SERVICE BULLETIN

Service Bulletin No.: DA20-25-01 Rev 0

Title: Installation of Rescue Hammer

Figure 1

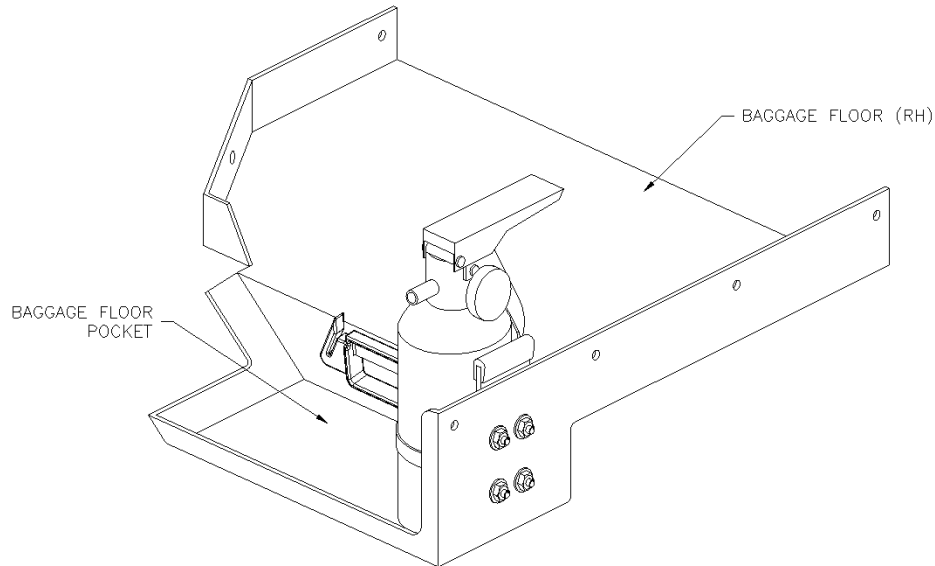
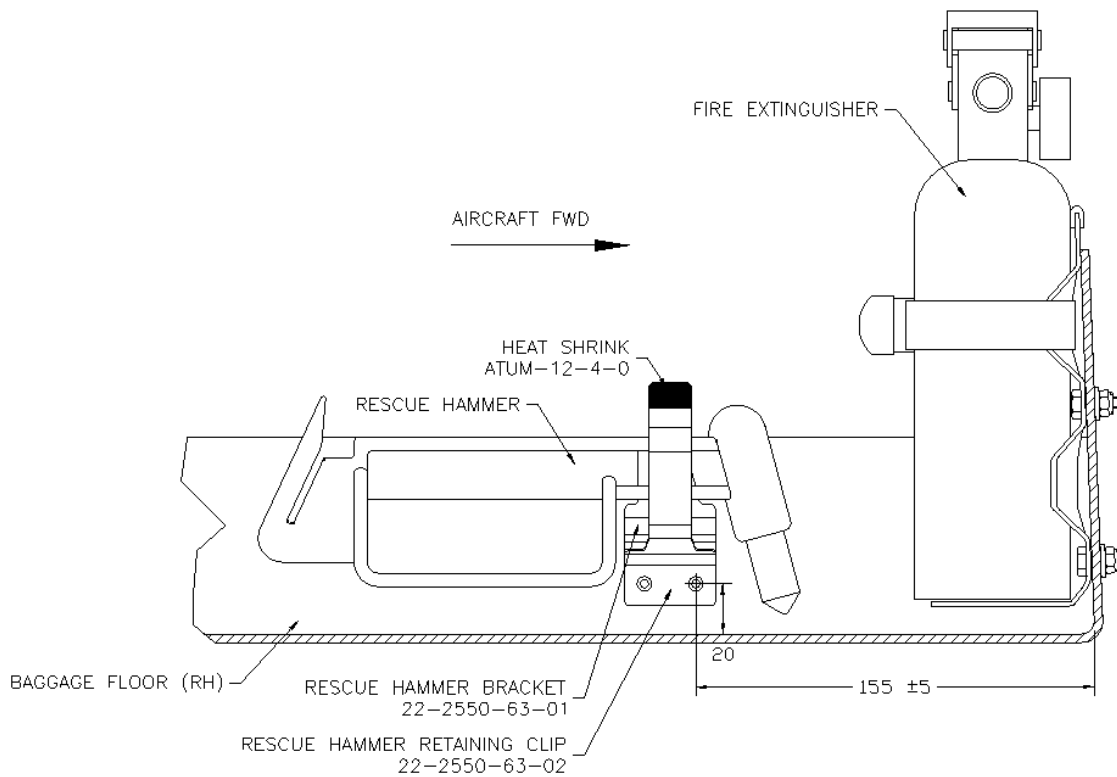
- 10.1 Remove the RH baggage floor as per AMM chapter 25-50-00.
- 10.2 Place the baggage floor on a suitable work table/bench.
- 10.3 Position rescue hammer bracket (p/n 22-2550-63-01) onto the baggage floor (Reference figure 1 and 2):
 - 10.3.1 Measuring from the baggage flange that attaches to the seatback, mark measurement of 155mm AFT.
 - 10.3.2 At the previously marked position, measure 20mm up from the surface of the baggage floor pocket and mark position.
 - 10.3.3 Center the forward bracket attaching hole at the marked location, verify measurements. Position upper edge of bracket parallel to upper surface of baggage floor.

10.3.4 Hold the rescue hammer bracket securely in place. Using a 1/8 inch drill bit transfer the two attaching holes to the baggage floor.

10.3.5 Open transferred holes in baggage floor using a #30 drill bit.

- 10.4 Position the rescue hammer bracket on the baggage floor. Position the rescue hammer retaining clip (p/n 22-2550-63-02) over the bracket as shown in Figure 2. Use Clecos as required.

- 10.5 Attach the rescue hammer bracket and retaining clip to the baggage floor using blind rivets (p/n BSCQ-04-05, rivet head outboard) and plain washers (p/n AN960C4). Position washers on the inboard side of the baggage floor.

- 10.6 Install heat shrink (p/n ATUM-12-4-0) on upper edge of rescue hammer retaining clip as shown in Figure 2.
- 10.7 Install the baggage floor as per AMM chapter 25-50-00. Ensure the installed rivets do not interfere with the fuel tank.

Figure 3

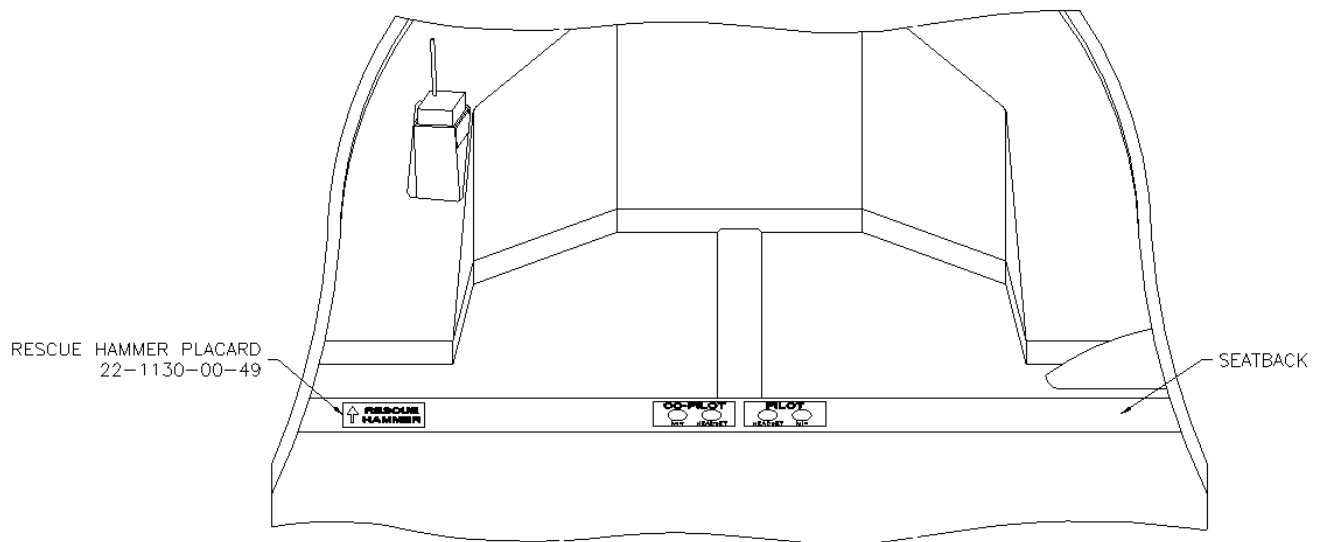
- 10.10 Install rescue hammer placard (p/n 22-1130-00-49) onto seatback as shown in Figure 3. Position placard in between canopy arm pivot and harness attachment.
